**BEFORE THE  
UNITED STATES CONSUMER PRODUCT SAFETY COMMISSION**

**COMMENTS OF  
RECREATIONAL OFF-HIGHWAY VEHICLE ASSOCIATION**

<b>16 C.F.R. Part 1422:</b>	)	
<b>Safety Standard for Recreational</b>	)	
<b>Off-Highway Vehicles (ROVs)</b>	)	
	)	<b>Docket No. CPSC-2009-0087</b>
<b>Notice of Proposed Rulemaking</b>	)	
	)	
<b>79 Fed. Reg. 68963 (Nov. 19, 2014)</b>	)

**June 19, 2015**

Figure 16—Hang tag<sup>43</sup>

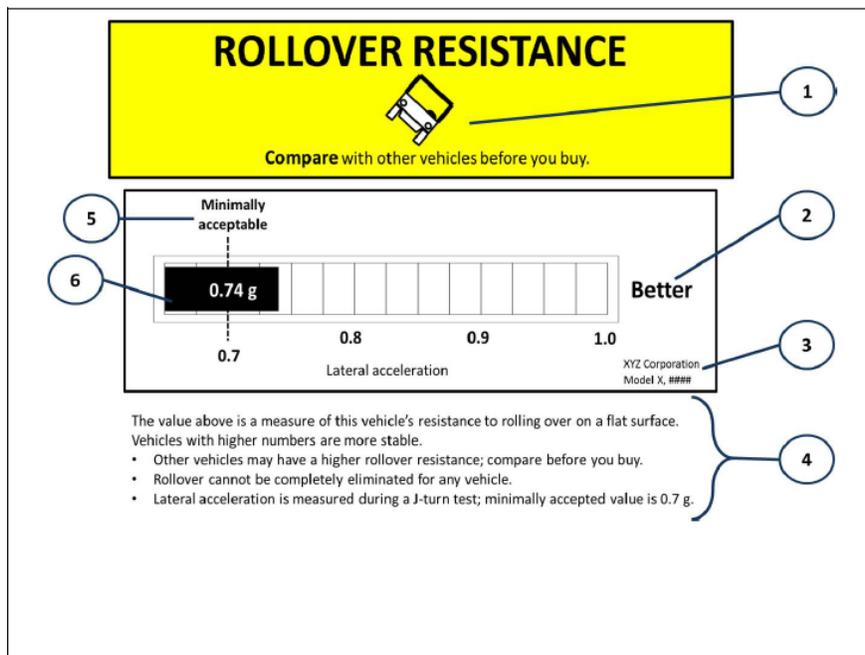
The proposed hang tag would depict a particular model ROV’s minimum lateral acceleration at two wheel lift as determined by the NPR J-turn test on asphalt on a sliding scale from approximately 0.65 to 1.0 (presumably omitting the “g” for simplicity). In addition, it indicates a value of 0.70 is “Minimally acceptable” and that closer to 1.0 is “Better.” The

In making this proposal, CPSC cites Section 27(e) of the CPSA, 15 U.S.C. § 2076(e) which authorizes CPSC to require manufacturers to notify consumers at the time of original purchase of performance and technical data “related to performance and safety as may be required to carry out the purposes” of the CPSA. 79 Fed. Reg. at 68993 (emphasis added). It further cites Section 2 of the CPSA which provides that one of the statutory purposes is to “assist consumers in evaluating the comparative safety” of products. *Id.*
